Access Compliance Report Public Rights-of-Way (Curb Ramps)

Main Street: N/A		Cross Street: BRIOSO_ST		Location:	E
ADA ID: RPRK211123113948	Ramp Type: Type 7 - Directional 2	Initial Pass/Fail: Fail	Overall Compliance: No	Severity Score:	15

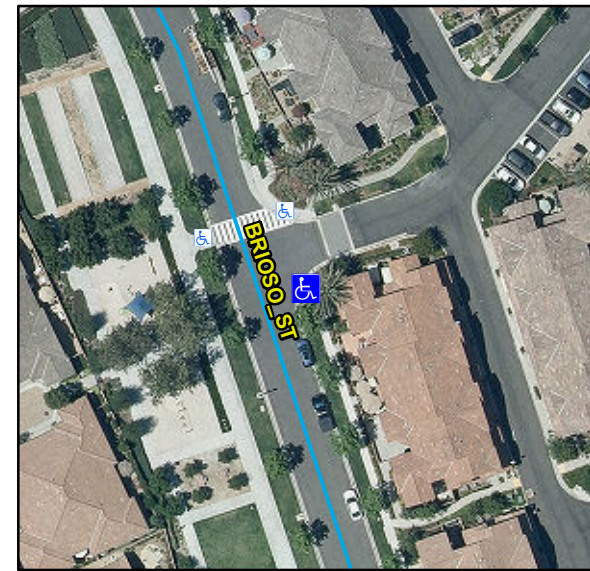
Compliance	Description	Data	Compliance	Description	Data
N/A	Ramp Length (in)	106	N/A	Flare Type LT	
Yes	Ramp Width (in)	48			N/A
No	Ramp Run Slope (%)	10.8	N/A	Flare Slope LT (%)	N/A
Yes	Ramp Cross Slope (%)	1.2	N/A	Flare Traversable LT	N/A
N/A	Grade Break	N/A	N/A	Flare Type RT	
N/A	Grade Break Slope (%)	N/A			N/A
N/A	Grade Break Cross Slope (%)	N/A	N/A	Flare Slope RT (%)	N/A
	Addl Para Ramp Left?	No	N/A	Flare Traversable RT	N/A
	Addl Para Ramp Right?	No	N/A	DWS Provided	N/A
N/A	Landing Present	N/A	N/A	DWS Contrast	N/A
N/A	Landing Length (in)	N/A	N/A	DWS Length (in)	N/A
N/A	Landing Width (in)	N/A	N/A	DWS Full Width	N/A
N/A	Landing Run Slope (%)	N/A		DWS Offset Type	N/A
N/A	Landing Cross Slope (%)	N/A	N/A	DWS Left Offset (in)	N/A
N/A	Landing Movement Obstructed?	N/A	N/A	DWS Right Offset (in)	N/A
	Landing Movement Type	N/A			
N/A	Landing Shared	N/A			
N/A	Marked Crosswalk 1	No	N/A	Clear Space	N/A
	Crossing 1 Direction	N	N/A	Clear Space To Crosswalk (in)	N/A

Possible Solutions:

Remove & Replace Entire Ramp.
